Council Report

To: Council **Date:** November 15, 2018
From: Andrea Hudson, Acting Director, Sustainable Planning and Community Development
Subject: **Update Report for Development Permit with Variances Application No. 00089 for 2501 Blanshard Street**

VICTORIA EVERGREEN TERRACE

2501 BLANSHARD STREET
VICTORIA, B.C.
V8X 3W5

DP-NORTH ELEVATION
 SCALE: 1:100

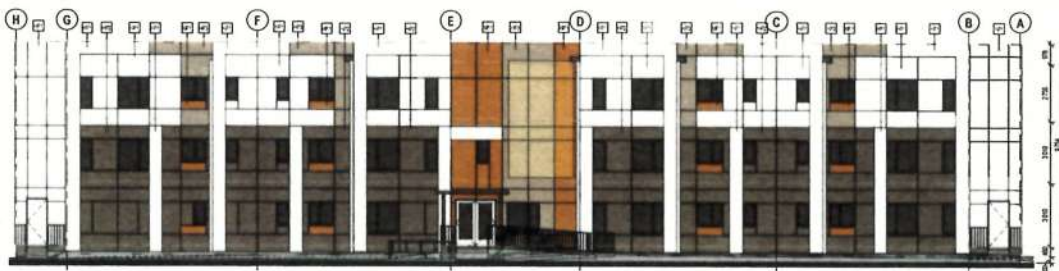
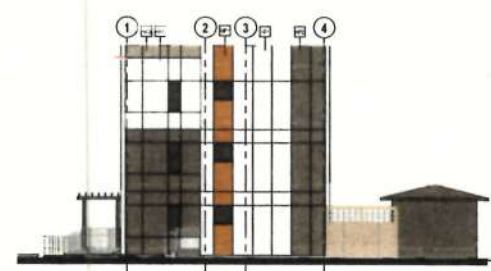
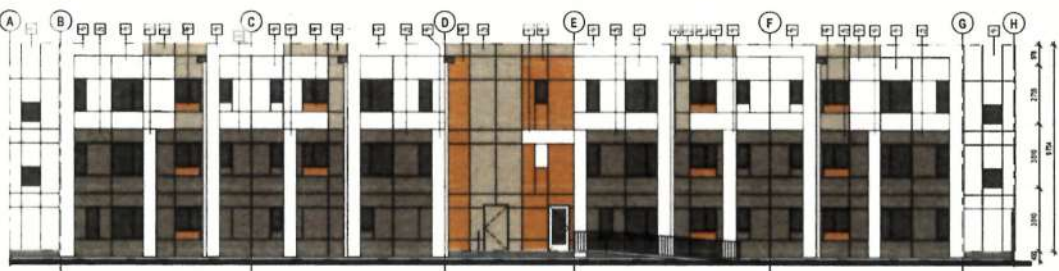
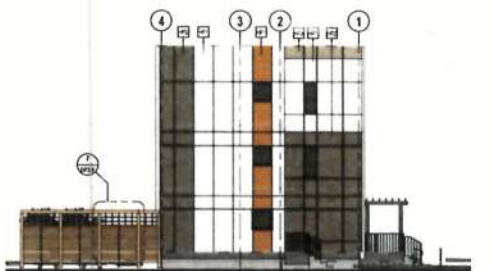
- *improve access to natural light through the window design*
- *simplify the façade design to establish an appropriate scale*
- *consider that the project, although intended for five years, may be on the site for a longer period of time*
- *improve the separation between the Hillside Avenue building frontage and the street, through shrub and boulevard tree plantings*
- *improve the amenity space including the incorporation of seating and picnic tables, with consideration to residents' privacy*
- *take a more natural approach to the form and character of the landscape design*
- *ensure consistency across all drawings, including three-dimensional perspectives which focus on the pedestrian experience.*

- improve access to natural light through the window design
- simplify the façade design to establish an appropriate scale
- consider that the project, although intended for five years, may be on the site for a longer period of time
- improve the separation between the Hillside Avenue building frontage and the street, through shrub and boulevard tree plantings
- improve the amenity space including the incorporation of seating and picnic tables, with consideration to residents' privacy

The front façade has been simplified in both colours and materiality, which helps establish a pedestrian scale. Many of the windows have been enlarged to allow natural light to further penetrate into the building. The proposed SRW will provide opportunities for boulevard trees in the future, and the new landscape plan uses a more natural shape to the rain garden as opposed to the previous rectangular shape. Finally, the rear yard amenity space includes a fence and patio furniture for residents' use and privacy.
